## ANN ARBOR HISTORIC DISTRICT COMMISSION

### Staff Report

**ADDRESS:** 1675 Broadway Street, Application Number HDC14-235

**APPLICATION:** The applicant seeks HDC approval to rebuild a portion of a retaining wall along the driveway on the north side of the lot. The wall ranges in height from 0' at the front lot line to 11' tall at the garage. The stone section to be replaced extends back 61' from the front lot line.

RETAINING WALL REPLACEMENT ELEVATION

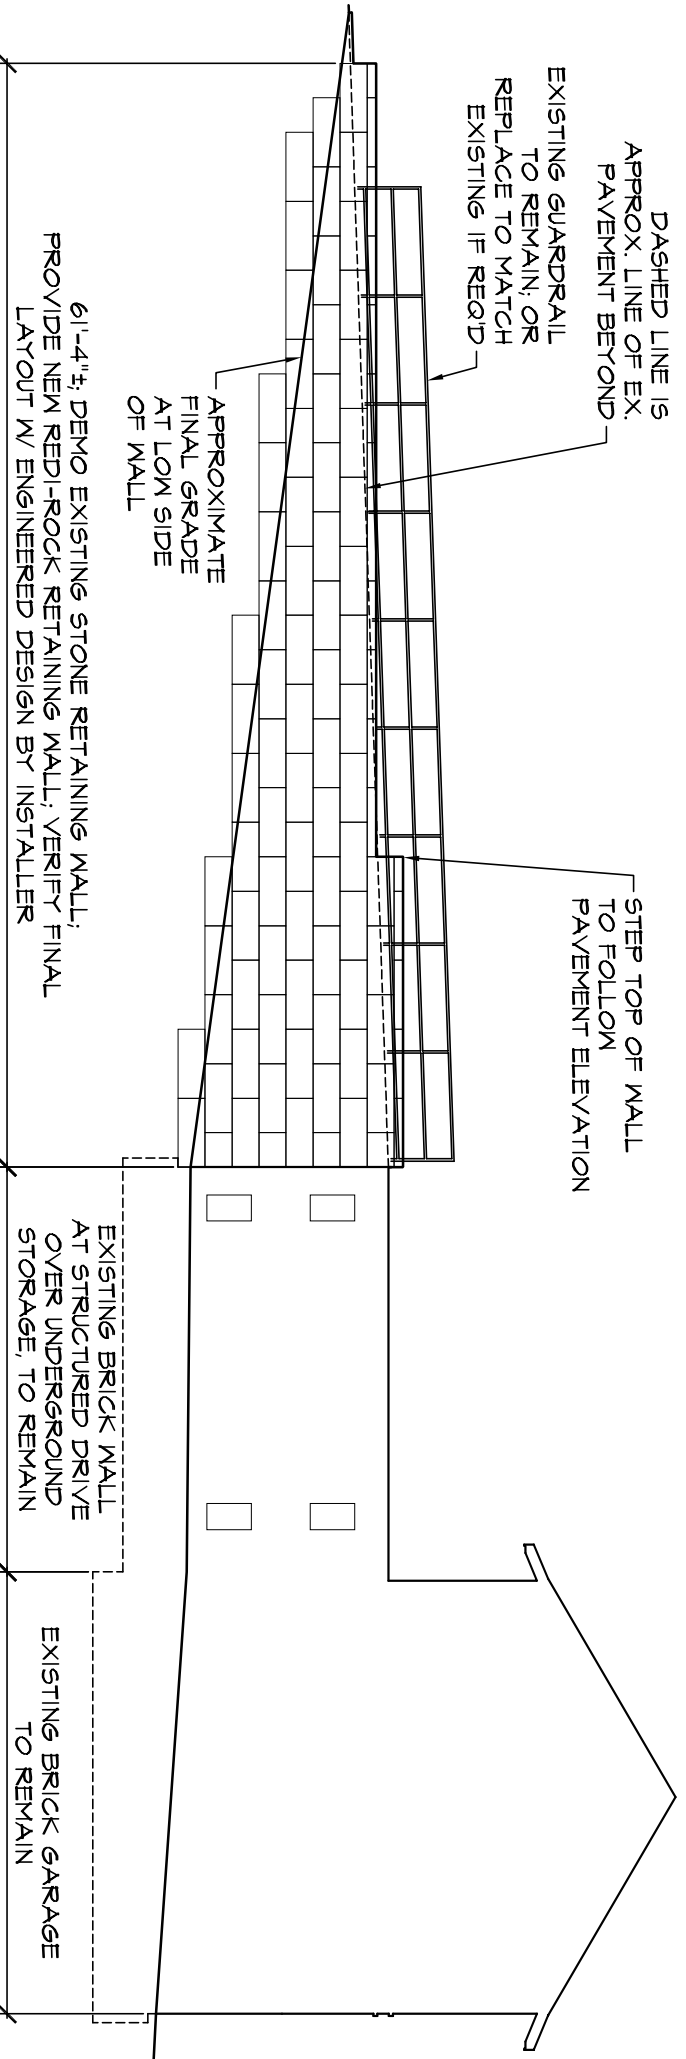
6'-4"± DEMO EXISTING STONE RETAINING WALL;  
 PROVIDE NEW REDI-ROCK RETAINING WALL; VERIFY FINAL  
 LAYOUT W/ ENGINEERED DESIGN BY INSTALLER
